HOUSTON LIGHTING & POWER COMPANY  
 ALLENS CREEK NUCLEAR GENERATING STATION - UNIT NO. 1  
 PRELIMINARY SAFETY ANALYSIS REPORT  
 AMENDMENT NO. 58  
 INSTRUCTION SHEET

This amendment contains information pertaining to PSAR Update. Each revised page bears the notation Am. No. 58, (5/81) at the bottom of the page. Vertical bars with the number 58 representing Amendment No. 58 have been used in the margins of the revised pages to indicate the location of the revision on the page.

The following page removals and insertions should be made to incorporate Amendment No. 58 into the PSAR.

U.H.S. CAUSEWAY - STABILITY ANALYSES  
FIGURE M-2

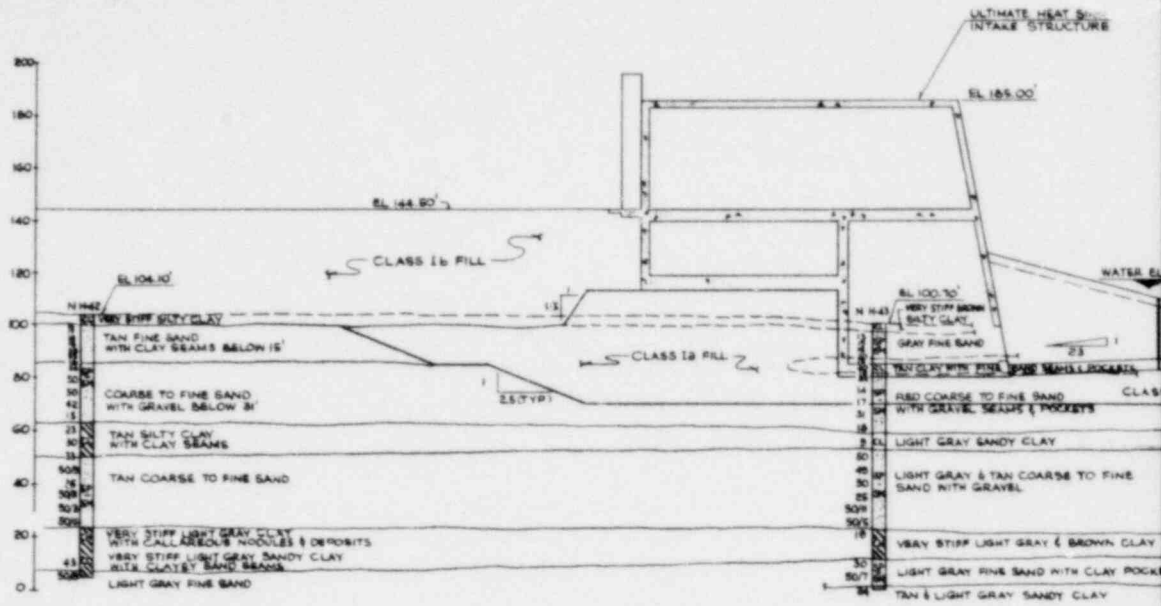
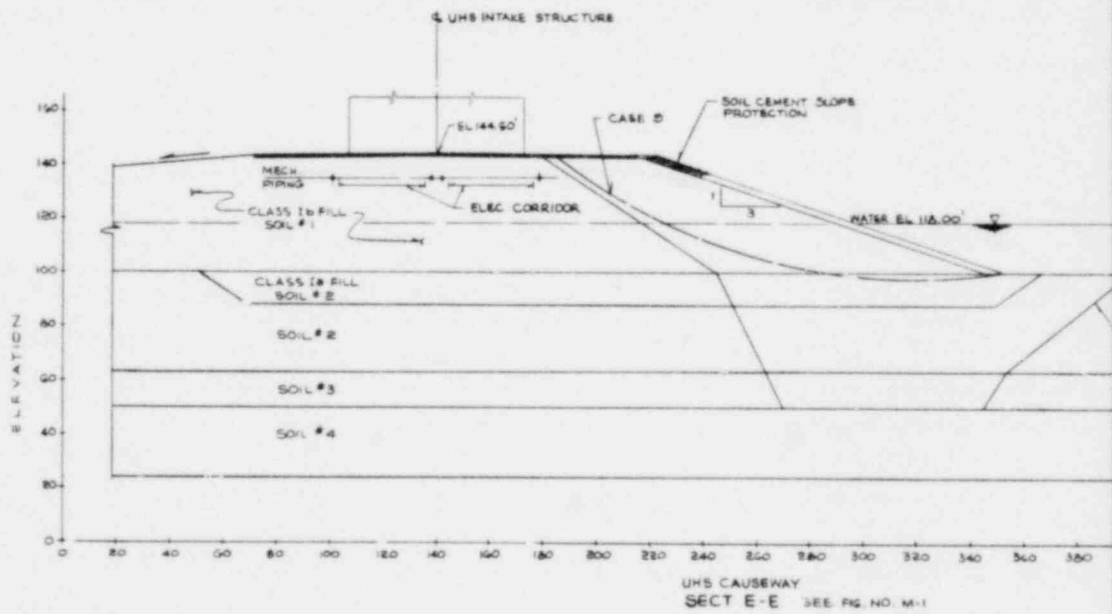
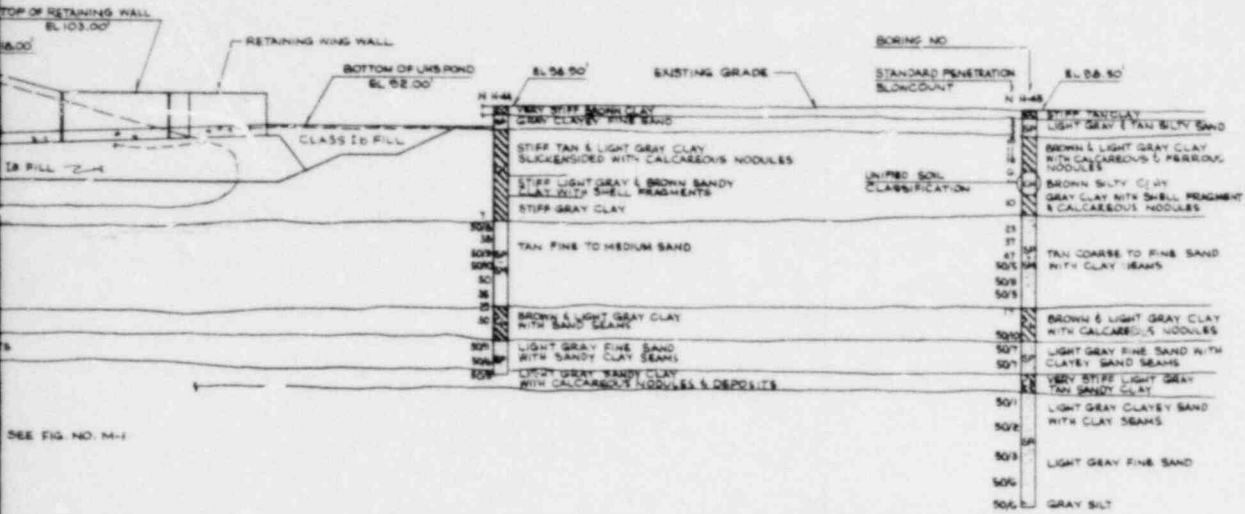
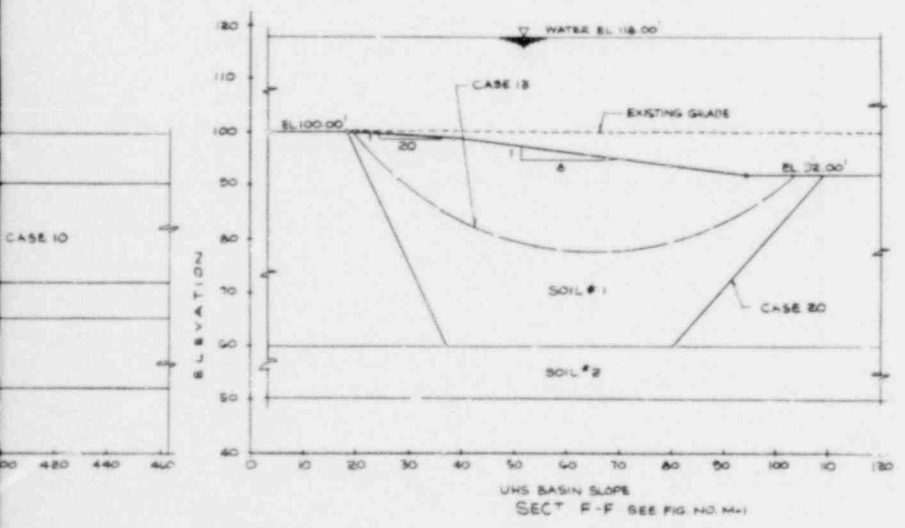
#### M8 UHS CAUSEWAY SLOPE STABILITY

In accordance with the design parameters and loading criteria outlined in Figure M-2, studies were performed to verify the design and the validity of the slope stability of the UHS Causeway. Directly underneath the Causeway there exists an approximate 50 foot thick layer of dense sand. This dense sand layer will act as a firm foundation and provide adequate support and sufficient stability for the Causeway. An analysis simulating a potential failure was conducted and postulated that the potential failure plane would occur within the recompacted material, i.e. the man-made Causeway. For this failure a minimum safety factor of 1.46 against seismic loading conditions as shown in Table M6 would result.

A parametric study was also performed using the Seismic Wedge Method, considering side friction along the potential failure plane. The failure plane was allowed to cut through 50 feet of dense sand, and to penetrate into the underlying clay layer. This study yielded a minimum safety factor of 1.34 and approximated the results obtained from the Simplified Bishop Method. Either method is considered acceptable and adequate for the Causeway design.

It should be noted that the constant excitation forces utilized in both wedge and Simplified Bishop Method slope stability analyses provide an extremely conservative approach in the case of an instantaneously back and forth earthquake motion of 10 second duration. This conservatism was also coupled with an unrealistic large amount of driving mass in the Wedge Method as indicated in Figure M-2. A comparison of these parametric study results is presented in Table M6.

In summary, the slope stability results as presented in Figure M-2 are extremely conservative, since they neglect all side friction forces along the failure planes, are coupled with unrealistically large amounts of driving mass, and neglect the low average soil design parameters. The minimum safety factors for the Causeway design are well within acceptable limits for different loading conditions as established by U.S. Army Corps of Engineers. (See PSAR Section 2.5 Appendix M Table M5.)

U.H.S. CAUSEWAY - STABILITY ANALYSES  
FIGURE M-2A

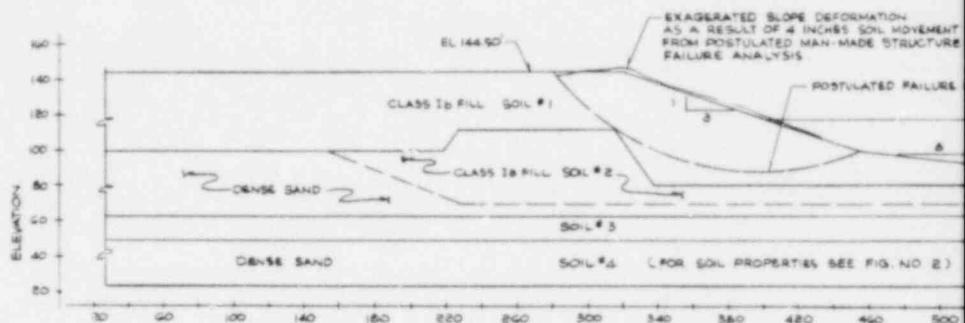
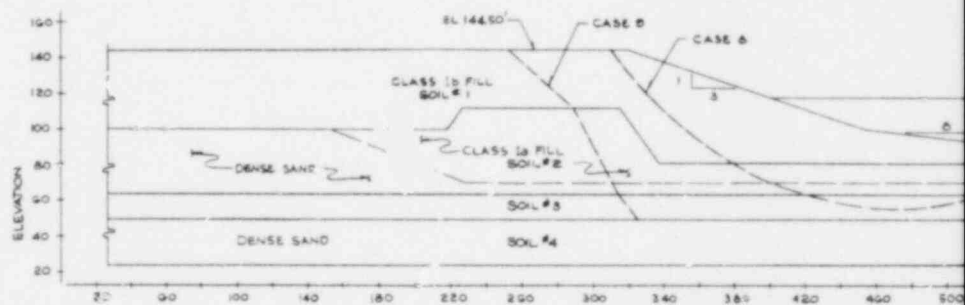
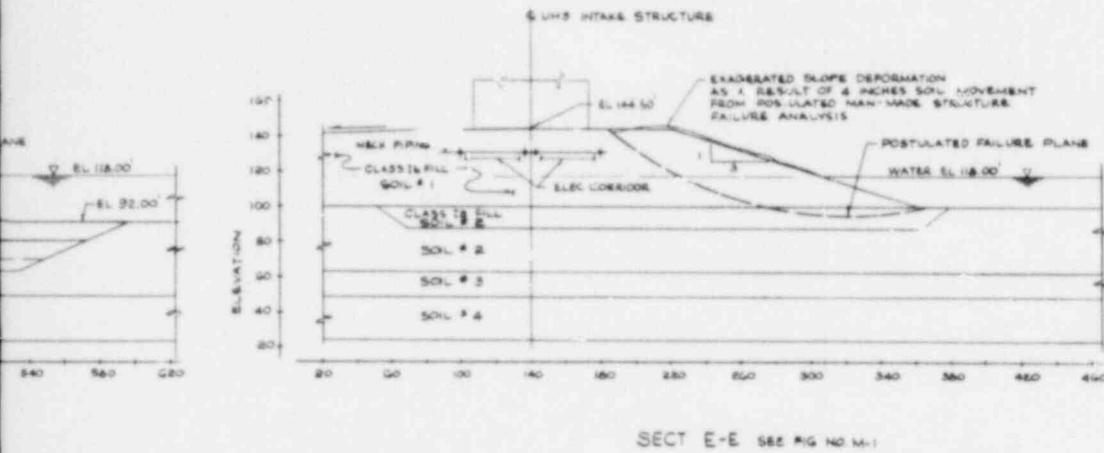
Furthermore, in accordance with the NRC Regulatory Guide 1.27, an analysis postulating the failure of the man-made Causeway was performed. A cross section taken at the lake front area was investigated for the potential blockage of the waterway should the Causeway be postulated to fail in this area. The results of the slope stability analysis along with postulated failure plane are presented in Figure M-2a.

The movement of the postulated failure plane was examined using Newmark's method (1) with a safety factor equal to 1, i.e. an impending failure of the Causeway slope. This yielded a conservative soil movement of less than 4 inches. This soil movement would produce a very minor bulging type of deformation which would be experienced in the Causeway along the lake front area (see Figure M-2a). As an additional conservatism and in order to provide a positive stoppage of soil movement, a concrete retaining wing wall structure will be provided at the Causeway/lake front area (see Figure M-1) to assure a continuous passage of cooling water into the fore-bay canal of the Ultimate Heat Sink Intake Structure.

FIGURE 3.5-2

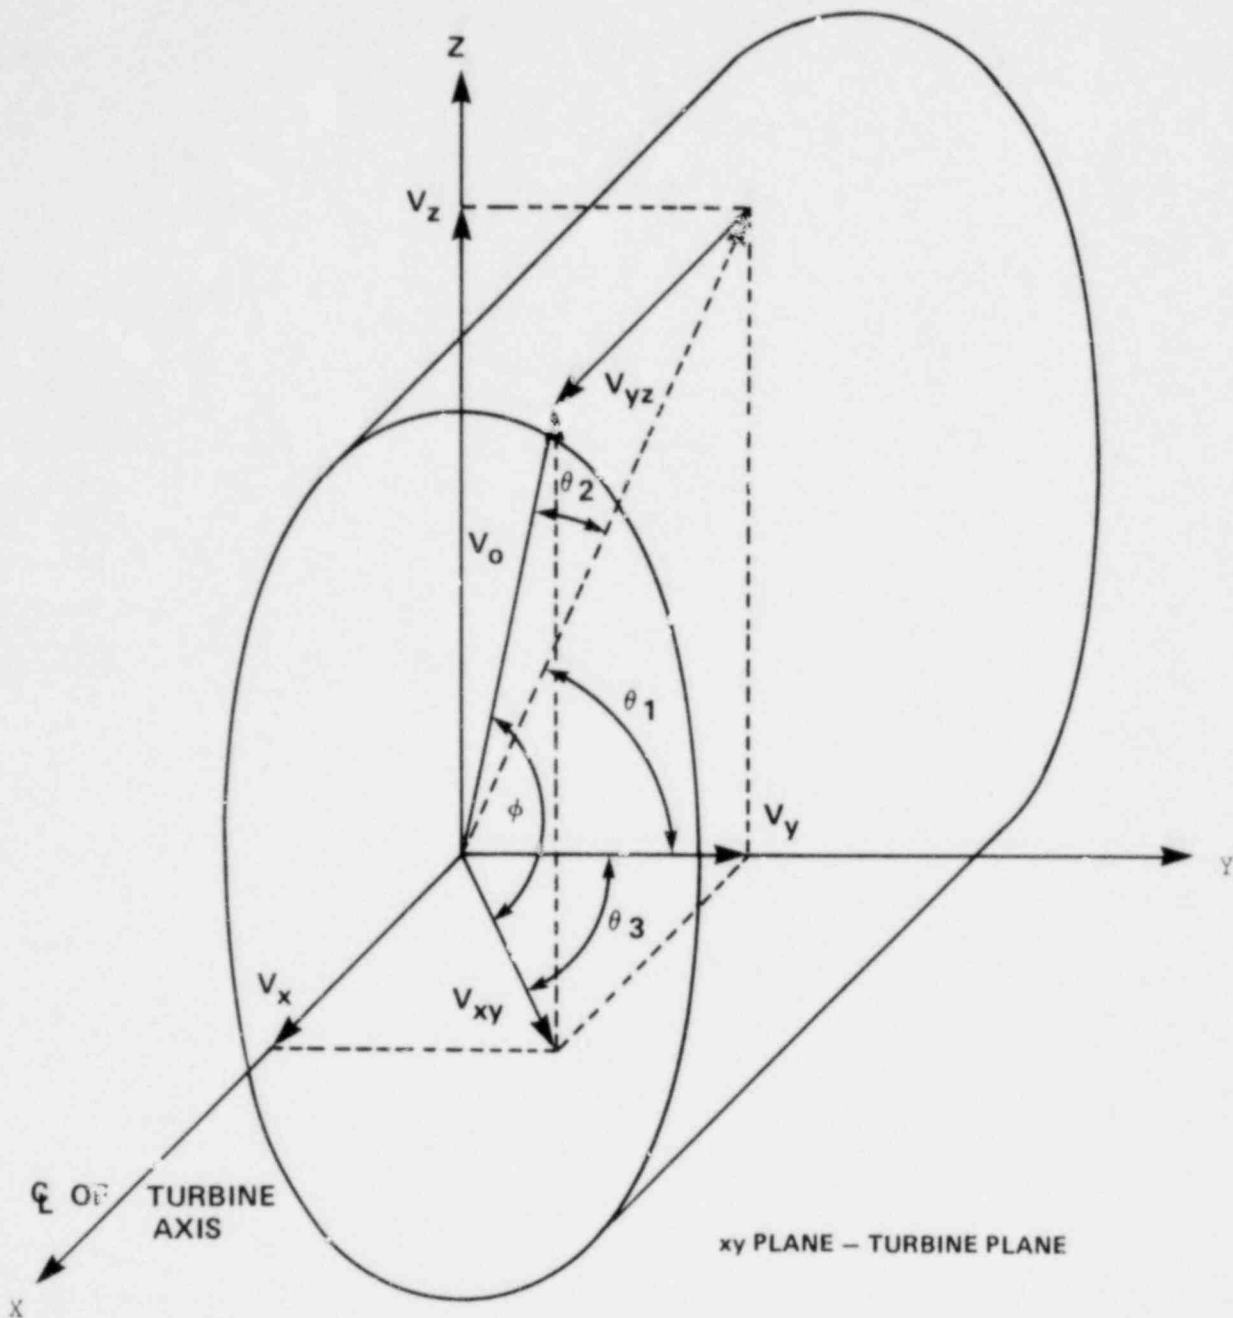
Figure 3.5-1 shows the relative location of low pressure elements of the turbines and the plant structures. Missiles may be ejected at any angle of the 360 degrees about the turbine axis. The missile ejection angles and directions are illustrated in Figure 3.5-2.

Tests have indicated (Reference 3.5-5) that deflection angles ( $\theta_2$ ) of turbine generated missiles will be close to zero ( $\pm 5$  degrees) for interior discs and 0 to 25 degrees for the last stage disc. A uniform probability distribution is assumed within this range of angles. To calculate the impact probability it was also assumed that a missile would be ejected with equal probability in the 360 degrees around the rotor axis ( $\theta_1$ ).
